QUALITY ASSURANCE -- NON-CONFORMANCE REPORT

Report No: NCR-000498

NCR #: ZPMC-0471

Reference Description: Missed MT indications by both ZPMC and ABF's QC in Segment 6AW

Longitudinal Open Rib Stiffener to FL3 Floor beam at PP44 CJP (FCW)

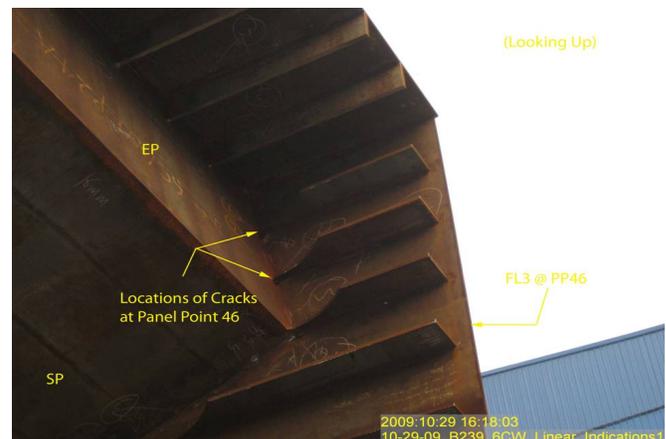
During random verification Magnetic Particle Testing of the internal components of OBG segment 6AW, Caltrans Quality Assurance (QA) Inspector discovered a total of two (4) longitudinal indications that measured from 25mm to 30mm in length. In addition to the (MT) indications these welds were visually rejectable due to notches in the weld toe and at the weld terminations. These welds were previously tested accepted by ZPMC and ABF (MT) technicians.

SEG031J-131 (1) 30 mm Longitudinal Indication.

Submit a repair procedure to the engineer for approval. Missed MT indications continue to be a chronic problem. Assure that adequate training of MT technicians occurs so these incidences are reduced.

Longitudinal Open Rib Stiffener to FL3 Floor beam at PP44 CJP (FCW)

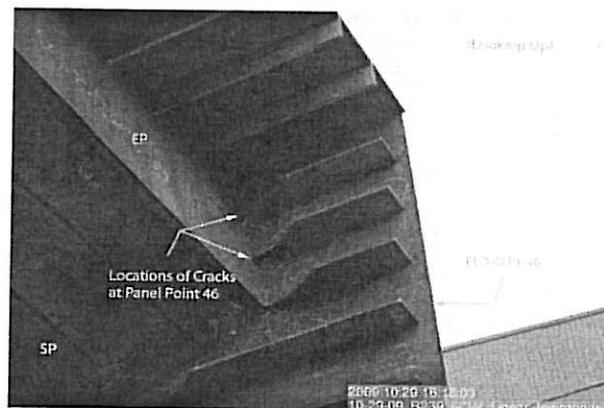
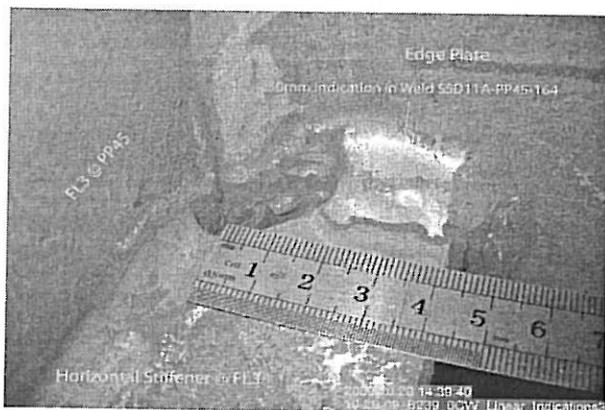
During random verification Magnetic Particle Testing of the internal components of OBG segment 6AW, Caltrans Quality Assurance (QA) Inspector discovered a total of two (4) longitudinal indications that measured from 25mm to 30mm in length. In addition to the (MT) indications these welds were visually rejectable due to notches in the weld toe and at the weld terminations. These welds were previously tested accepted by ZPMC and ABF (MT) technicians.

Horizontal FL3 stiffeners (X8) to edge plate attachment fillet welds (FCW)

Weld No. SSD11A-PP45-164 = (1) 30mm Longitudinal Indication.

Weld No. SSD12A-PP46-170 = (1) 25mm Longitudinal Indication.

Weld No. SSD12A-PP46-175 = (1) 30mm Longitudinal Indication.

SEG031J-131 (1) 30 mm Longitudinal Indication.

- 1. 这次返修时，QC和Leader CWI到现场对打磨，焊接进行指导和监控工作以保证返修按照处理意见进行；
- 2. 整个返修的过程，QC和Leader CWI应该有批准CWR的复印件；
- 3. 去除热影响区域上在各个方向上不小于25mm范围内的油漆；
- 4. 将杂物以及MT检测遗留的残留物清理干净。然后采用打磨的方法去除裂纹，打磨前预热至65° C。对于单个裂纹返修，打磨返修范围为沿缺陷焊缝每一端加50mm；
- 5. 如果打磨时母材损伤，则在返修前将损伤区域打磨干净；如果打磨时或打磨后根部间隙大于5mm，则在继续返修前另需递交文件给工程师予以审核批准，并按照被批准的方法将角焊缝改成CJP焊缝；
- 6. 焊接前按照新的焊接返修工艺准备各焊缝接头形式；
- 7. 返修前，VT和MT检测确认返修区域没有裂纹及其他缺陷存在，同时靠近裂纹的母材也要做MT，保证没有裂纹延伸到母材。如果在母材上发现裂纹，则另外需CWR，且只有当这份另出的CWR批准后才能继续返修；
- 8. 将杂物以及MT检测遗留的残留物清理干净。按照WPS进行预热和焊接，预热温度为160° C-230° C；
- 9. 焊接后WPS要求进行后热，后热温度为230° C-315° C，后热时间至少1个小时；
- 10. 后热后将焊缝逐渐冷却到周围环境温度，并控制冷却速率不超过50° C每小时；
- 11. 后热后将修补区域打磨与母材或相邻焊缝平齐；
- 12. 在焊缝冷却至环境温度至少经过48小时以后进行NDT检查；
- 13. 返修后根据图纸进行MT检测，并按照合同10-1.59“钢结构”中的“检测和试验”要求进行附加MT检测。对于CJP焊缝，NDT为VT，MT和UT。

- 1. QC and a Lead CWI shall be present, direct and supervise all grinding and welding operations during this repair to ensure the repair is per the disposition requirements

- 2. QC and a Lead CWI shall have an approved copy of the CWR in hand prior to the repair.
- 3. Remove paint ≥25mm in all direction of HAZ prior to MT.
- 4. Clean the excavation area of all loose debris including MT powder. Preheat to 65° C before removing cracks by grinding, repair area shall extend a minimum of 50mm beyond each end of single crack repairs.

- 5. If base metal is damaged by grinding, the damaged area shall be ground clean prior to performing weld repair. If gap >5mm is found during or after grinding, comply with the notification on changing fillet weld to CJP which is submitted for Engineer's review and approval form.

- 6. Prepare excavation in accordance with the New Repair Procedure prior to welding.
- 7. Before this repair, Verify with VT and MT repair areas are defects free, and also MT shall be performed on the base metal laying abroad cracks to ensure that no cracks were propagated to the base metal. Separate CWR approval is needed if cracks are found in the base metal, and only after this new CWR's approval can continue the repair.

- 8. Clean excavation area of all loose debris including MT powder after excavation. Preheat and weld according to repair WPS, the preheat shall between 160° C-230° C.

- 9. Perform post weld heating according to repair WPS, the postheat shall between 230° C-315° C and for one hour minimum.
- 10. Allow the weld to cool to ambient temperature gradually. Control cooling rate after PWHT to no more than 50° C per hour.

- 11. Grind the repaired area flush with base metal or the adjacent weld after post weld heating.
- 12. Wait 48 hours at least after the repair area has cooled to ambient temperature before performing NDT.

- 13. Perform MT inspection to all repair area according to Contract Drawings along with all additional NDT required by the applicable notes Special Provision Section 10-1.59 'Steel Structure', subsection 'inspection testing'. NDT include VT, MT and UT if it is a CJP weld.
